PARTIDGE – WOOD SUBDIVISION

FINAL PLAT COMMENTS (should be addressed prior to submitting the FINAL PLAT for review and/or signature by the City Engineer):

Revised for the June 4th meeting:

SITE PLAN

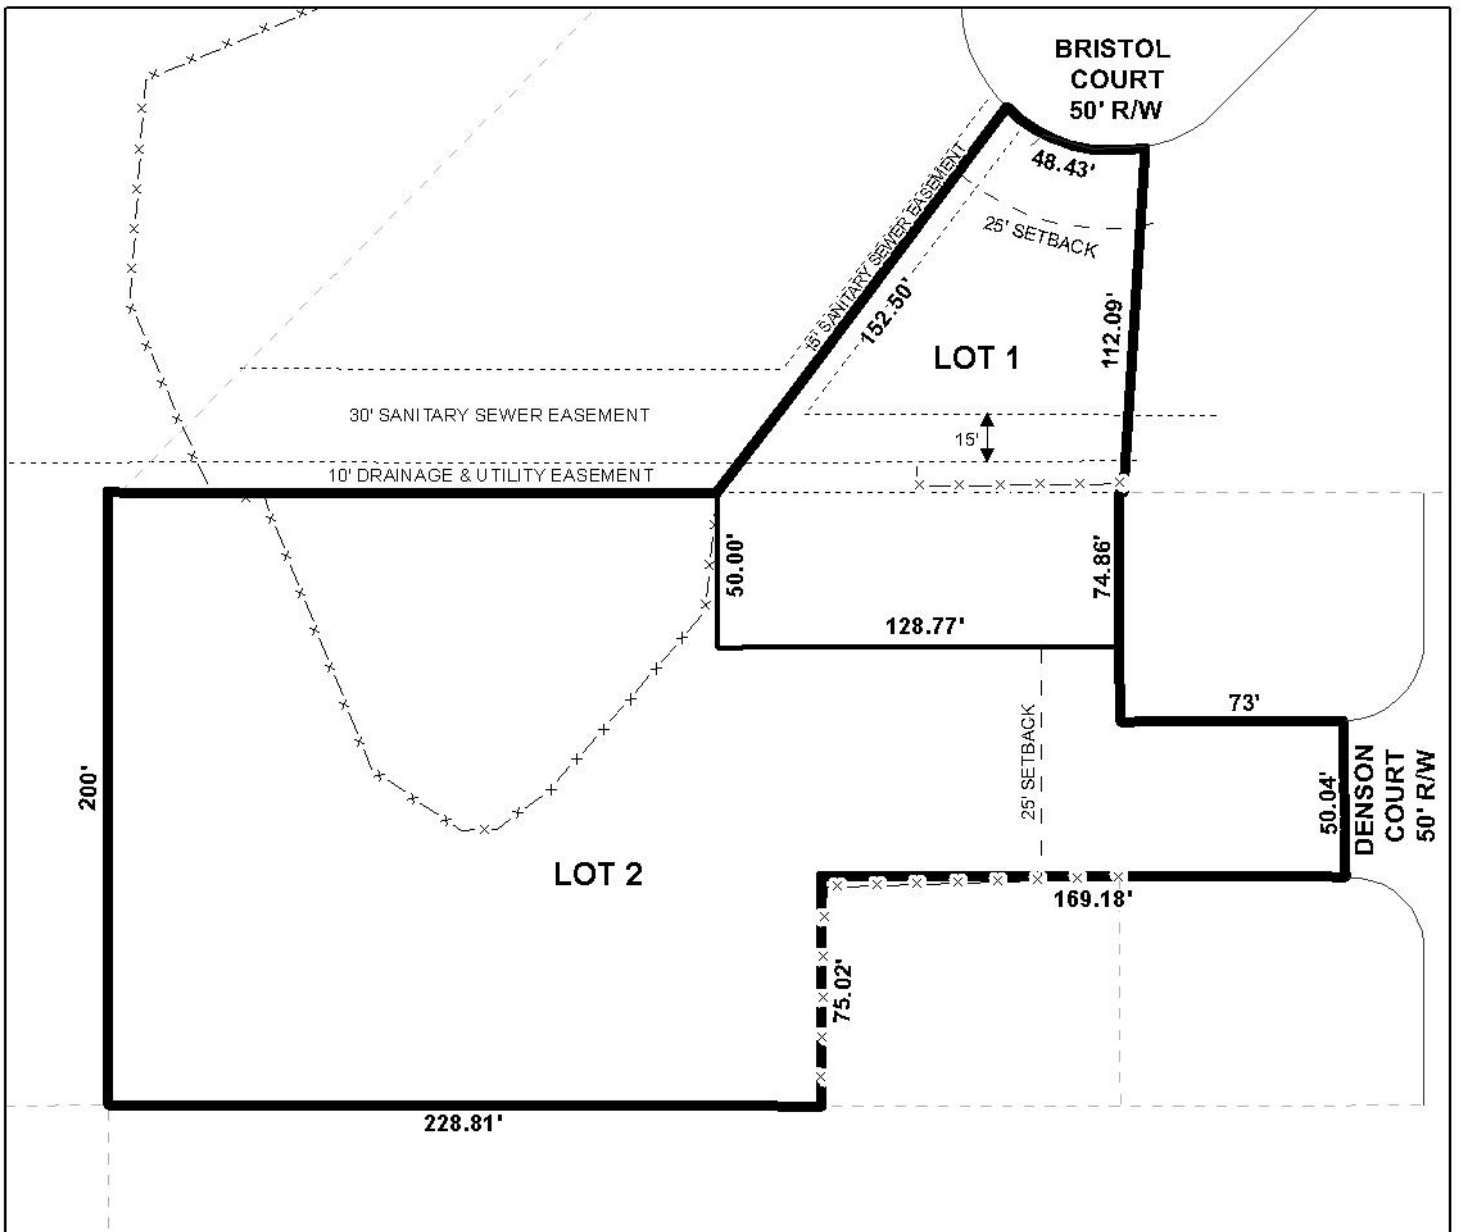
The preliminary plat does not illustrate setbacks along the frontages of either of the proposed lots. As such, if approved, the Final Plat should be revised to illustrate a 25-foot minimum building setback line along all frontages for both lots.

- 1) revision of the Final Plat to either illustrate a 50-foot right-of-way for both Bristol Court and Denson Court, or dedication to provide 25-feet from the centerline;

- 2) revision of the Final Plat to illustrate a 25-foot minimum building setback along Bristol Court and Denson Court;
- 3) retention of the lot size labels in both square feet and acres on the Final Plat or the furnishing of a table on the Final Plat providing the same information;

The proposed Lot 1 fronts Bristol Court, a minor street with curb and gutter requiring a 50-foot right-of-way. Lot 2 has frontage on Denson Court, a minor street without curb and gutter which typically requires a 60-foot right-of-way width. However, at the April 5, 1973 meeting of the Planning Commission, the Denson Court Subdivision was approved illustrating a 50-foot right-of-way width for this portion of Denson Court. As such, and with a waiver of Section V.B.14. of the Subdivision Regulations, a reduced right-of-way width may be appropriate and should be reflected as such on the Final Plat, if approved.

- 1) retention of the 25-foot minimum building setback along Bristol Court and Denson Court on the Final Plat;*
- 2) retention of the lot size labels in both square feet and acres on the Final Plat or the furnishing of a table on the Final Plat providing the same information;*
